# Stormwater Detention and Infiltration Design Data Sheet SDI-Design Data v2.00, Released January 2020

### Stormwater Facility Name: Northcrest Center Sub.

## Facility Location & Jurisdiction: **NW Corner Constitution and Canada Drive**

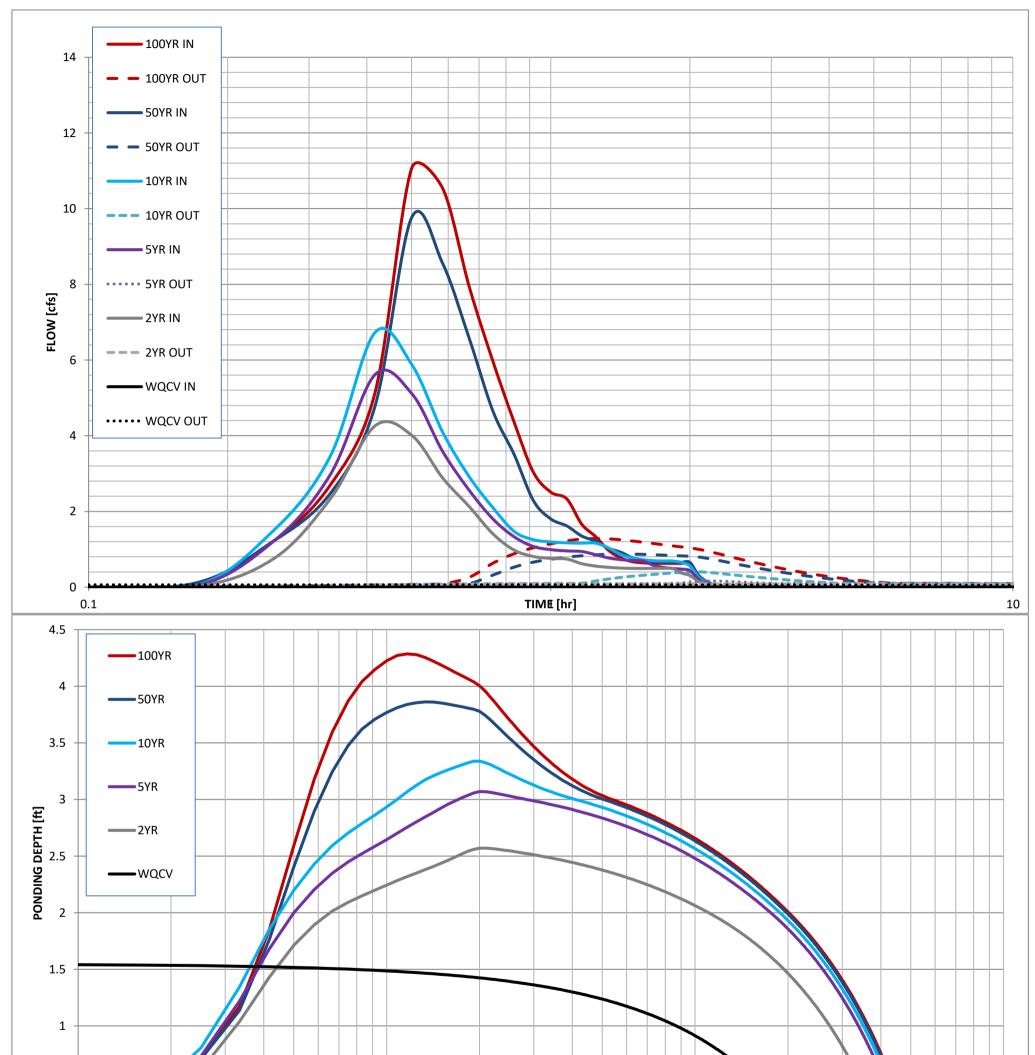
er Input: Watershed Characteristics	500	1	Revise this input to match MHFD-Detention	User Defined	User Defined	User Defined	User Define
Extended Detention Basin (EDB)		4	spreadsheet in FDR. It	Stage [ft]	Area [ft^2]	Stage [ft]	Discharge [cf
Watershed Area =		acres	has this inputted at 3.17ac	0.00	100	0.00	0.01
Watershed Length =		ft	3.1780	1.00	2,753	1.00	0.05
Watershed Length to Centroid =		ft		2.00	4,300	2.00	0.07
Watershed Slope =		ft/ft		3.00	4,644	3.00	0.10
Watershed Imperviousness =		percent		4.00	4,795	4.00	1.00
Percentage Hydrologic Soil Group A =		percent		5.00	4,932	5.00	2.00
Percentage Hydrologic Soil Group B =		percent		6.00	5,100	6.00	4.75
Percentage Hydrologic Soil Groups C/D =	-	percent					
Target WQCV Drain Time =		hours					
Location for 1-hr Rainfall Depths (	use dropdown)	1					
User Input	-						
	rainfall depths hydrographs Hydrograph F Once CUHP h information h interpolate th	s, click 'Run C using the emb Procedure. as been run a as been provi e Stage-Area- mary results	aputs above including 1-hour CUHP' to generate runoff abedded Colorado Urban and the Stage-Area-Discharge vided, click 'Process Data' to a-Volume-Discharge data and in the table below. Once this PDF'.
